## MEMORANDUM

**SUBJECT:** The Spicewood Water and Wastewater SER #4029 and 4030

# **The Spicewood Water and Wastewater Service Extension Request #4029 & 4030**

# SER #4029

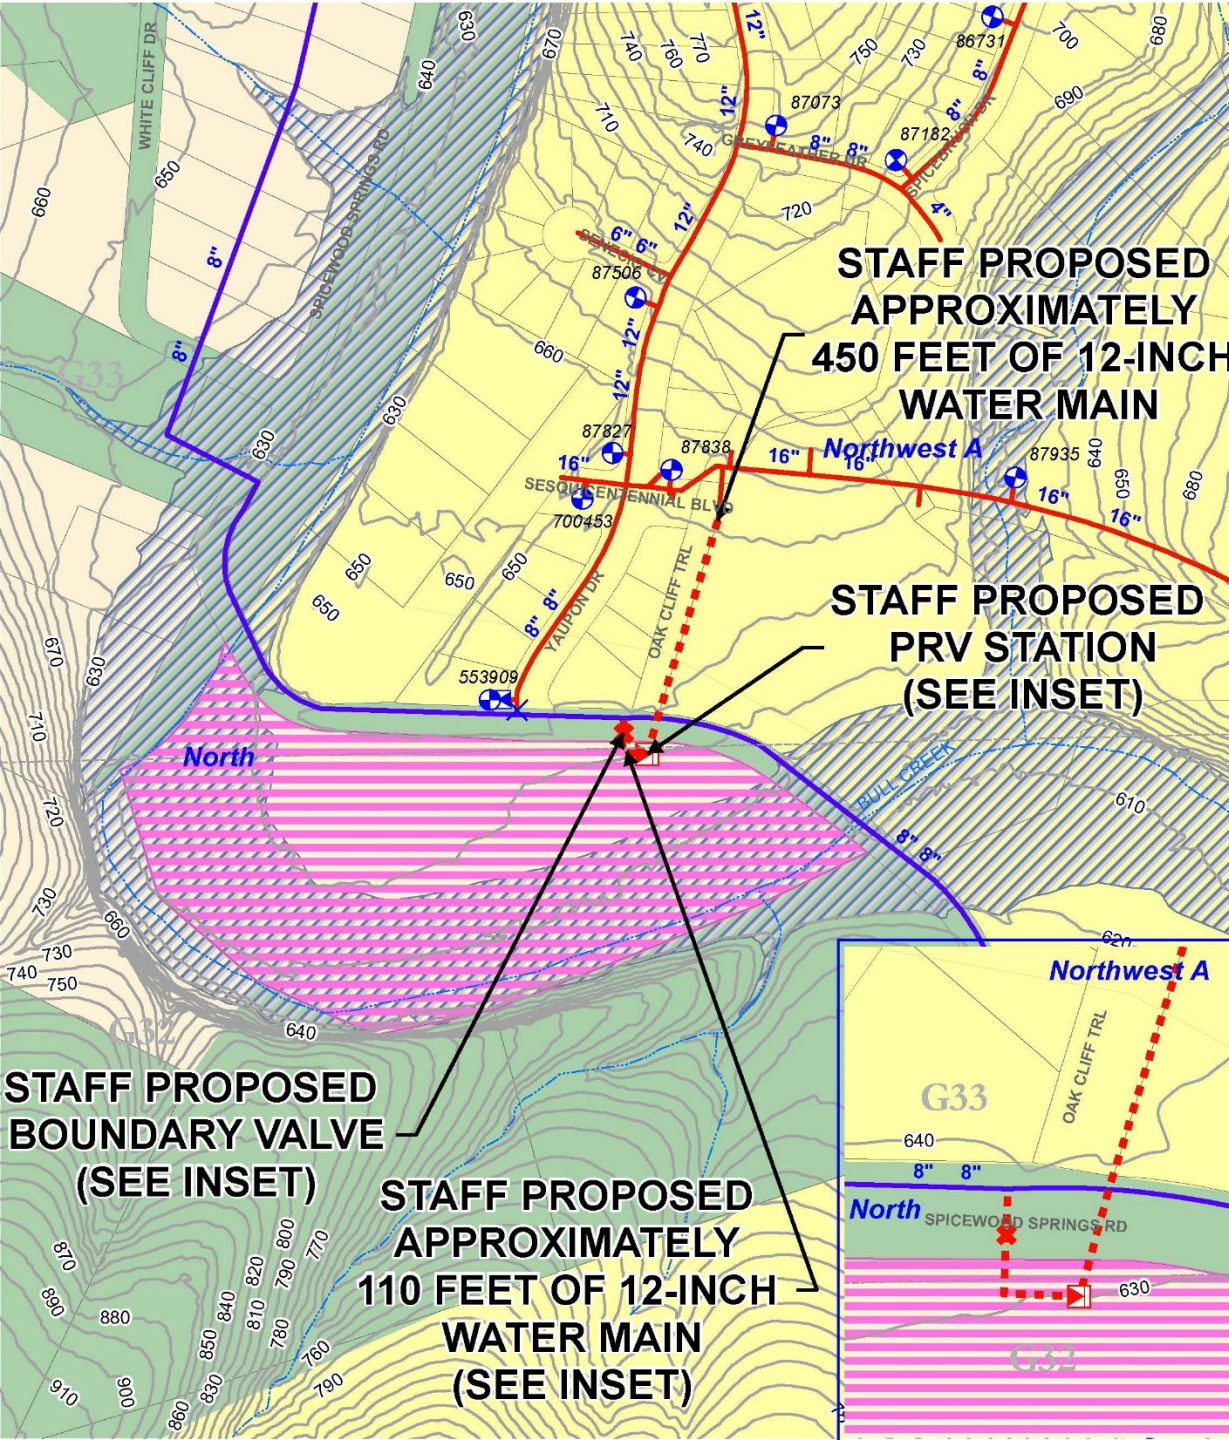
- Approximately **450 feet of 12-inch water main** from the existing main at Sesquicentennial Blvd and Oak Cliff Trail into the subject tract.
- Approximately **110 feet of 12-inch water main** from the proposed PRV station on Spicewood Springs Road and install a boundary valve then connect to the existing 8-inch water main (North Pressure Zone) on Spicewood Springs Road.

The applicant has met with a contractor who stated that the proposed development would likely need two wells to provide the amount of water needed to sustain the proposed development and the on-site water storage for fire flows.

# SER #4030 Summary

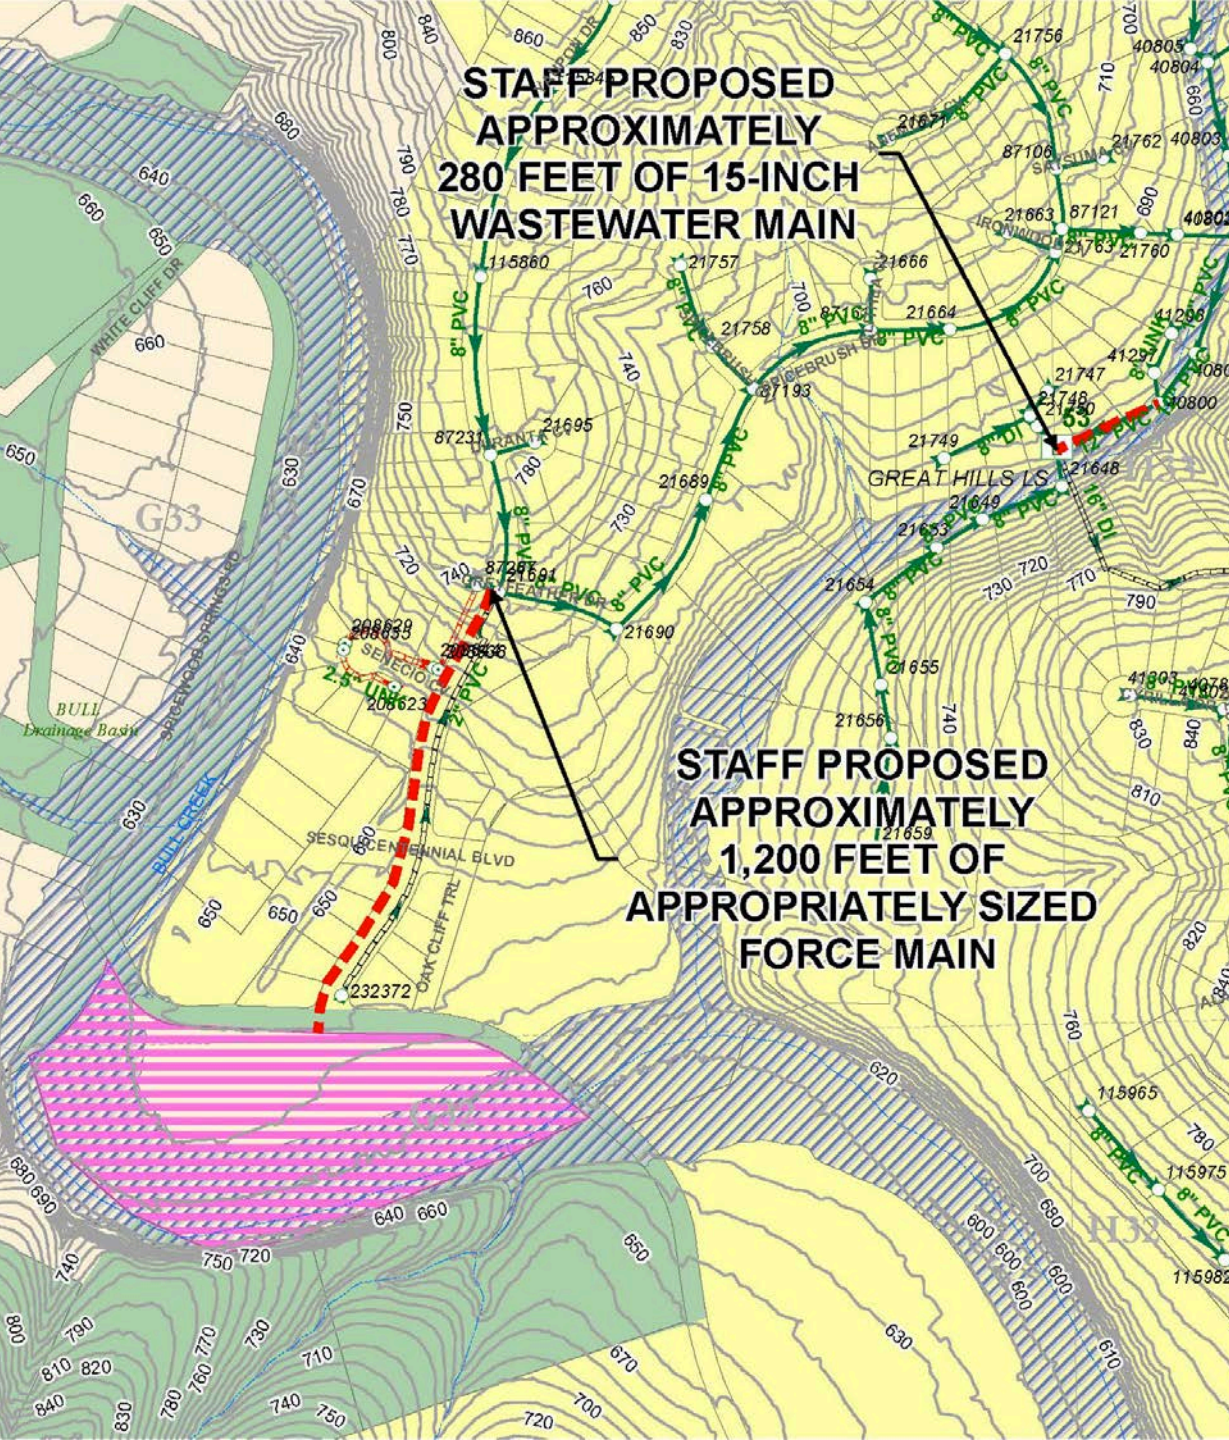
- Approximately **1,200 feet of appropriately-sized wastewater force main** from the existing 8-inch gravity wastewater main on Yaupon Drive at Greyfeather Drive.
- The applicant would also construct approximately **280 feet of 15-inch gravity wastewater** main to replace the existing 12-inch gravity wastewater main at Great Hills Lift Station east to the existing manhole. All existing services would be reconnected to the proposed 15-inch gravity wastewater main.

The site would need to construct a wastewater treatment plant after obtaining either a wastewater land application permit or a wastewater discharge permit from the Texas Commission on Environmental Quality. A wastewater land application permit would require substantial area to be dedicated for disposal fields in addition to potential buffer requirements from wells and surface water resources.
